ENERGY NORTHWEST

Subject: **COLUMBIA GENERATING STATION, DOCKET NO. 50-397
RESPONSE TO REQUEST FOR ADDITIONAL INFORMATION RELATED
TO LICENSE AMENDMENT REQUEST FOR CONDENSATE STORAGE
TANK TECHNICAL SPECIFICATIONS**

RESPONSE TO REQUEST FOR ADDITIONAL INFORMATION RELATED TO LICENSE AMENDMENT REQUEST FOR CONDENSATE STORAGE TANK TECHNICAL SPECIFICATIONS

Figure 1-1, RCIC LS-15A/15B Analysis

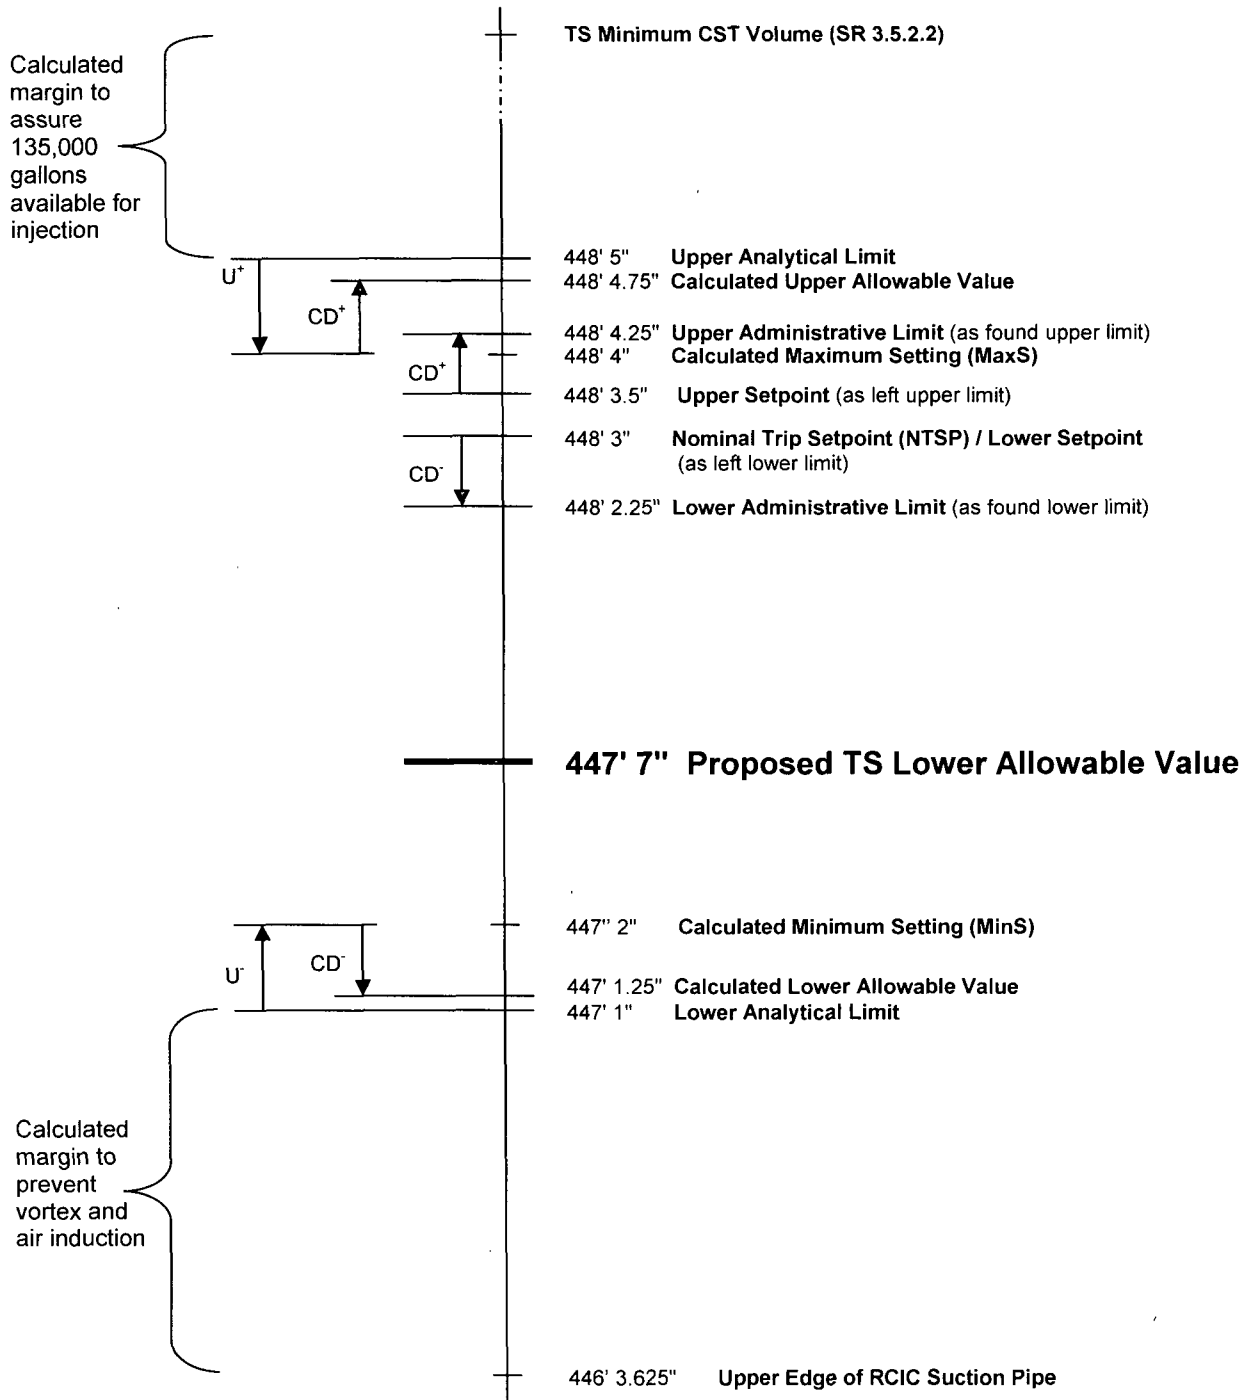
Setpoint Calculation Methodology: Provide documentation (including sample calculations) of the methodology used for establishing the limiting setpoint (or NSP) and the limiting acceptable values for the As-Found and As-Left setpoints as measured in periodic surveillance testing as described below. Indicate the related Analytical Limits and other limiting design values (and the sources of these values) for each setpoint.

Methodology - The setpoints for Reactor Core Isolation Cooling (RCIC) level switches RCIC-LS-15A/15B were developed using the methods established in Energy Northwest procedure EES-4 (Reference 1), similar to ISA RP67.04.01 Method 3 (Reference 2). Energy Northwest Calculation E/I-02-93-1272 (Reference 3) documents the lower and upper analytical limits of RCIC-LS-15A/15B. Refer to Figure 1-1 for an overview of the values associated with RCIC-LS-15A/15B. The applicable "as-found," "as-left," and Technical Specification (TS) allowable values (AVs) are specified in surveillance procedures.

Lower Analytical Limit - The lower analytical limit is established to prevent vortexing and air induction into the common suction line for RCIC from the Condensate Storage Tank (CST). Per calculation E/I-02-93-1272, the lower analytical limit of the switch has been determined to be 447' 1". Based on this and the device uncertainties (U^-), the calculated minimum setting (MinS) for this device is 447' 2". Subtracting the calibration and drift (CD) term, the calculated lower AV is 447' 1.25". For additional conservatism, a margin of 5.75" between the calculated lower AV and the proposed TS AV of 447' 7" is requested.

The Columbia Licensee Controlled Specifications (LCS) conservatively establishes a Nominal Trip Setpoint (NTSP) of $\geq 448' 3"$ for these switches. The setting tolerances are specified at +0.5" / -0.0" (448' 3.5" to 448' 3"). Therefore, when considering the CD term, the lower administrative limit is determined to be 448' 2.25".

Upper Analytical Limit - The upper analytical limit is established to assure that 135,000 gallons of water have been transferred before RCIC-LS-15A/15B swaps RCIC pump suction to the Suppression pool. The upper analytical limit for this switch has been determined to be 448' 5". Based on this and the device uncertainties (U^+), the calculated maximum setting (MaxS) for this device is 448' 4" and adding the CD term, the calculated upper allowable value is 448' 4.75".
